Service Letter No. 405

SUBJECT: Inspection of Upper Nose Gear Oleo Bearing

MODELS AFFECTED: PA-22 Tri-Pacer, PA-22-108 Colt, PA-22-135, PA-22-150, PA-22-160 Tri-Pacer

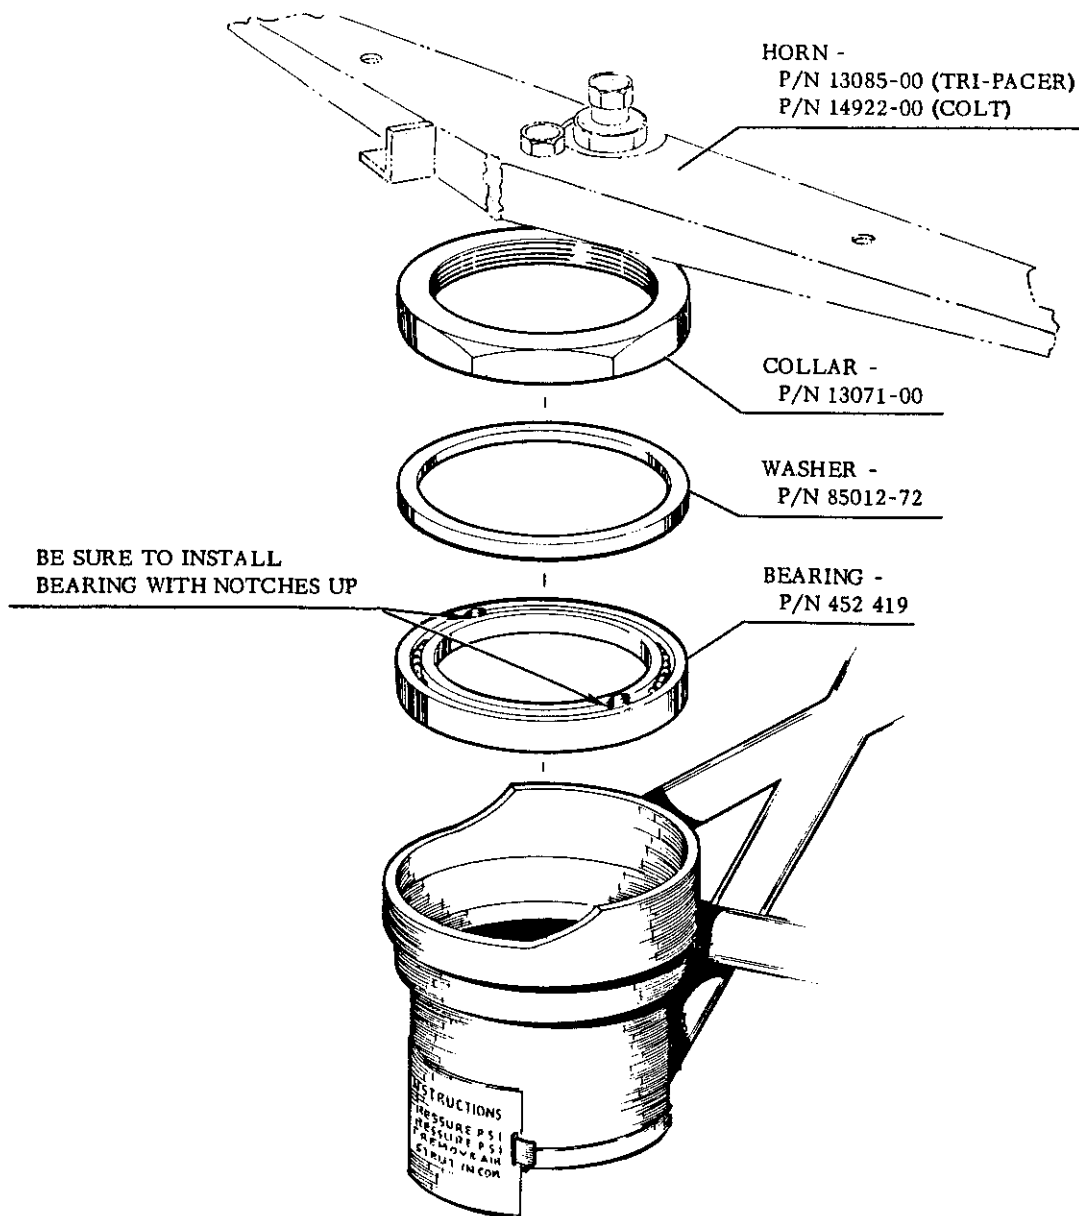
A number of reports have been received indicating that movement of the nose gear can be restricted due to binding of the upper nose gear oleo bearing, part number 452 333, due to lack of lubrication.

Loss of the balls from the bearing races has also been experienced due to excessive wear and the bearing being installed with the loading grooves facing downward.

An inspection of the aircraft indicated above is requested to determine the condition of the upper oleo bearing as well as the position of the loading grooves. This inspection can be accomplished by removing the nose gear steering horn, part number 13085-00 on the Tri-Pacer and part number 14922-00 on the Colt; then removing the threaded collar, part number 13071-00, and seal washer, part number 85012-72.

If the bearing is in satisfactory condition and installed with the loading grooves facing upward, the bearing should be lubricated with MIL-G-3278 lubricant and the steering mechanism reassembled and inspected every 500 hours thereafter.

If the loading grooves are not visible it will be necessary to lower the oleo assembly to remove the bearing. The bearing should be removed, checked, lubricated and installed as indicated above, with the bearing loading grooves facing upward.

If the bearing is not in satisfactory condition, it should be replaced with sealed bearing, part number 452 419. When part number 452 419 bearing has been installed, the above inspections may be discontinued; the bearing should be checked for condition every 1,000 hours.

BEARING SHOULD BE LUBRICATED WITH MIL-G-3278 LUBRICANT.
